From: Marilyn L. Schweitzer [REDACTED]
Sent: Saturday, September 28, 2019 5:58 PM
To: Planning; Laff, Allison; Venard, Erin
Cc: Novack, William; katie wood; Council
Subject: Public Comment for the October 2 , 2019 PZC Meeting: File Number 19-917
Attachments: MLS-PublicCommentPZC2019Oct02.pdf

Public Comment for the October 2 , 2019 PZC Meeting: File Number 19-917

Painting of the masonry surface at 22 E. Chicago Avenue, Naperville (River Square) should be denied. Careful deliberation went into establishing the Design Standards and they should be taken seriously.

Map 1: Downtown Future Land Use

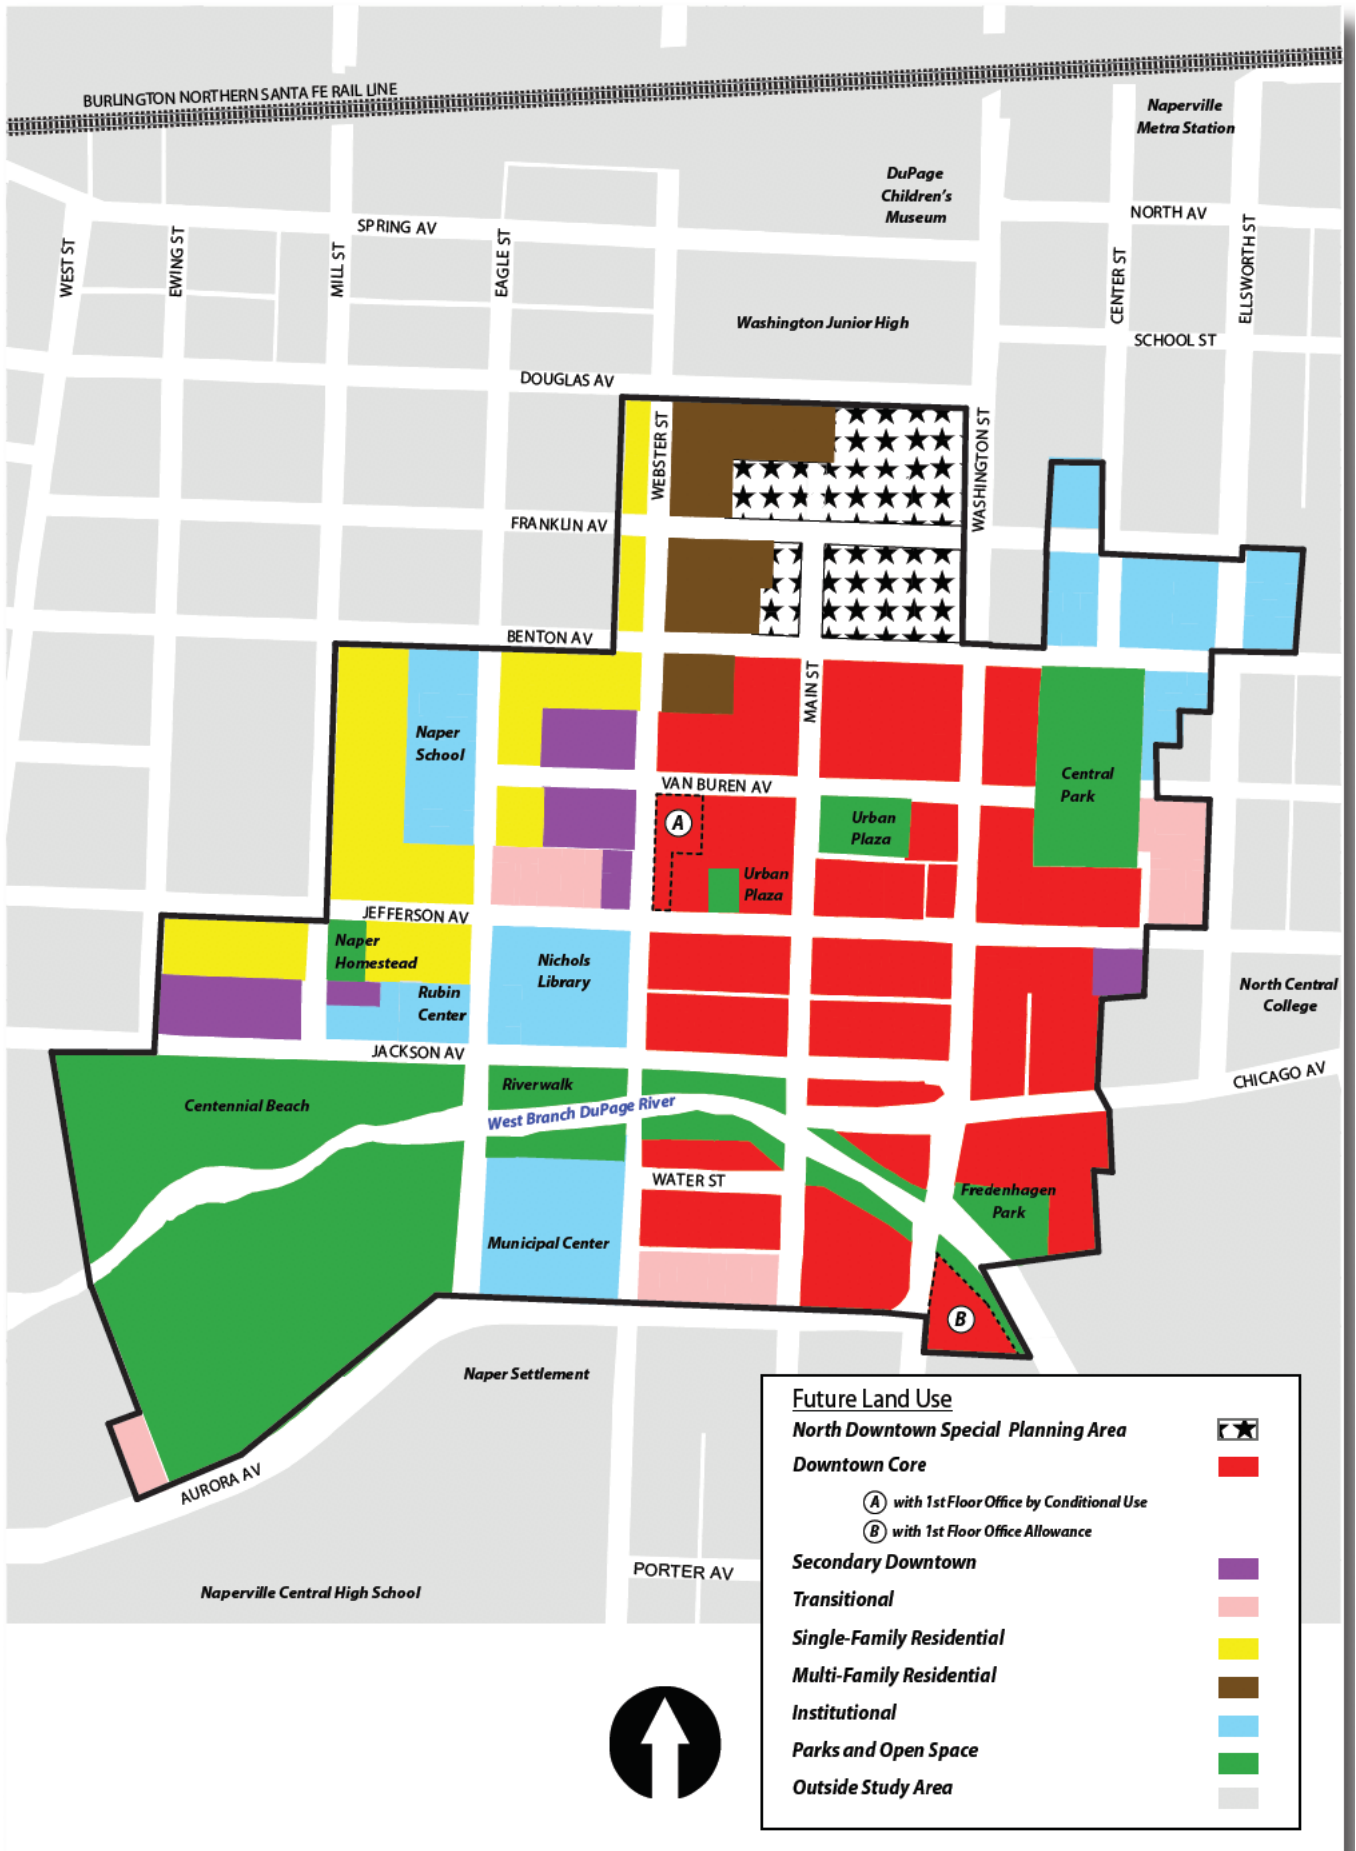
1. The argument that River Square should be exempt because it was built in 1989 and is not a historic building irrelevant. Page 4 of the 2011 Design Standards clearly show that River Square is a part of the downtown core and the Design Standard was established well after River square was built. Please see attached that map.

Overall Streetscape Map

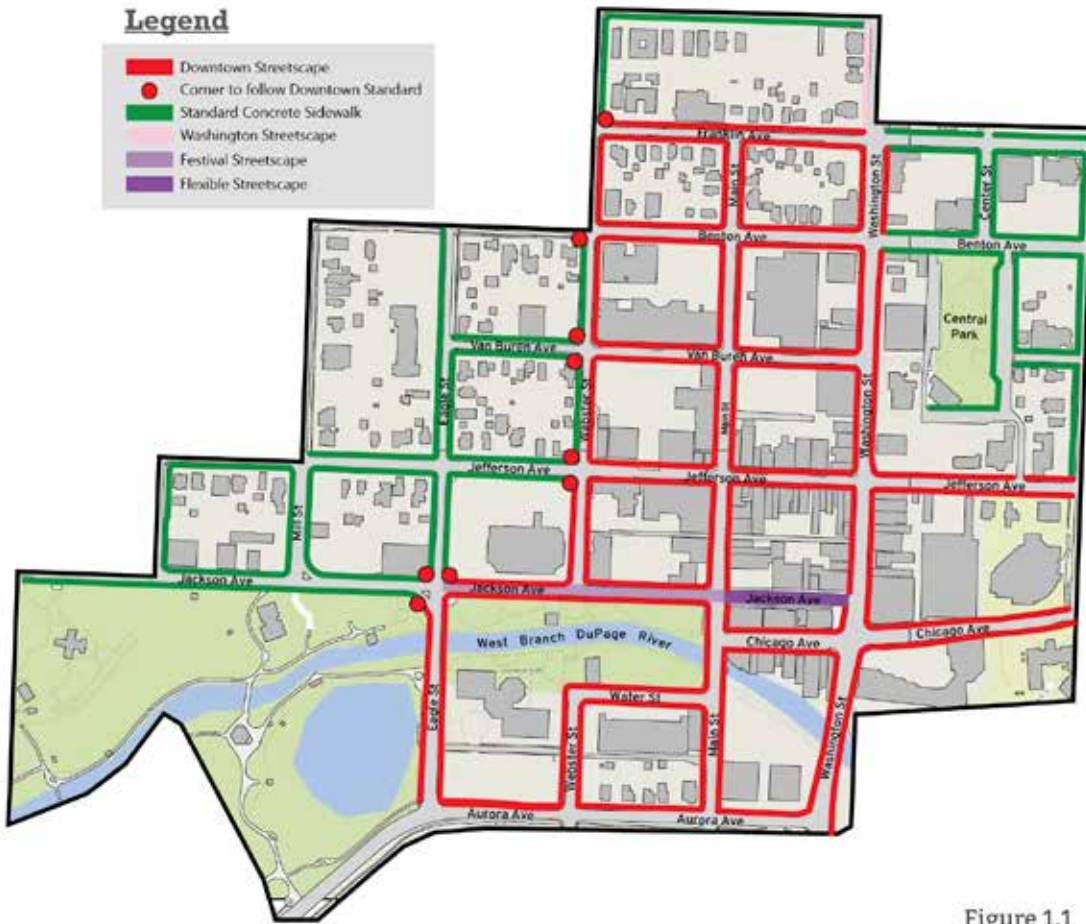
- Fort Hill Residence Hall (directly to the east)
5. As part of the Downtown core, River Square is bound by the [Downtown Streetscape Standards](#) endorsed by the Downtown Advisory Commission and approved by City Council on June 4, 2019. This standard has a red blend amenities area and black trash cans. Please see the attached elements of this standard. The aesthetic desired by the Downtown Streetscape standard blends well with the existing red brick exterior of River Square. Painting the masonry and swapping out black trash cans for white conflicts with the desired Downtown Streetscape aesthetic and would be overall unappealing.
